Access Compliance Report

Public Rights-of-Way

(Curb Ramps)

Intersection ID: 31509	Main Street: CARLEEN_WAY_DR	Cross Street: WILGROVE_WAY_DR	Location: W
ADA ID: D59F9B008163	Ramp Type: PerpDiag	Initial Pass/Fail: Fail	Overall Compliance: No
Severity Score: 8.75			
Codes/Mitigation Info/Possible Solution		Field Measurements/Component Compliance

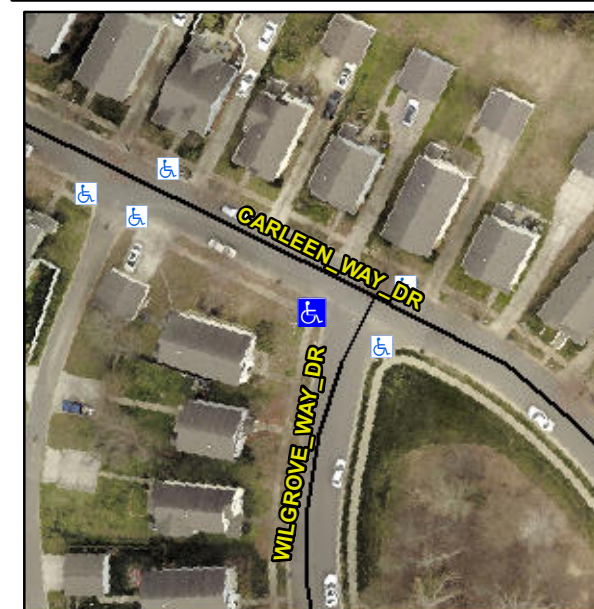
Not Found, R304.5.1

Compliance	Description	Data	Compliance	Description	Data
N/A	Ramp Length (in)	24.0	Yes	Ramp Slope (%)	5.2
No	Ramp Width (in)	38.0	Yes	Ramp XSlope (%)	1.1
N/A	Flare Type LT	N/A	N/A	Flare Type RT	N/A
N/A	Flare Slope LT (%)	N/A	N/A	Flare Slope RT (%)	N/A
N/A	Flare Traversable LT?	N/A	N/A	Flare Traversable RT?	N/A
N/A	Landing Length (in)	N/A	N/A	DWS Provided?	N/A
N/A	Landing Width (in)	N/A	N/A	DWS Contrast?	N/A
N/A	Landing Slope (%)	N/A	N/A	DWS Length (in)	N/A
N/A	Landing X Slope (%)	N/A	N/A	DWS Full Width?	N/A
N/A	Landing Curb? (Y/N)	N/A	N/A	DWS Offset (in)	N/A
N/A	Shared Landing?	N/A			
N/A	Gutter Ponding?	N/A	N/A	Gutter Slope (%)	N/A
N/A	Gutter Lip Ht (in)	N/A	N/A	Gutter X Slope (%)	N/A
N/A	Painted X Walk1?	No	N/A	Painted X Walk2?	No
	X Walk 1 Direction	To SE		X Walk 2 Direction	To NE
N/A	X Walk 1 Width (in)	N/A	N/A	X Walk 2 Width (in)	N/A
	X Walk 1 Slope (%)	6.1		X Walk 2 Slope (%)	0.1
	X Walk 1 X Slope (%)	2.1		X Walk 2 X Slope (%)	2.2

N/A	Ramp inside XWalk1?	N/A	N/A	Ramp inside XWalk2?	N/A
	Road Slope (%)	0.5	N/A	Clear Space?	N/A
	Road X Slope (%)	4.9	N/A	Clear Space to XWalk (in)	N/A
N/A	Any Obstructions?	N/A	N/A	Storm Grate/Utility Hazard?	N/A
	Obstruction Type			Storm Grate/Utility Type	
		N/A			N/A
			Yes	Surface Condition? (G/P)	Good

Remove & Replace Curb Ramp With Two New Directional Ramps or Equivalent.
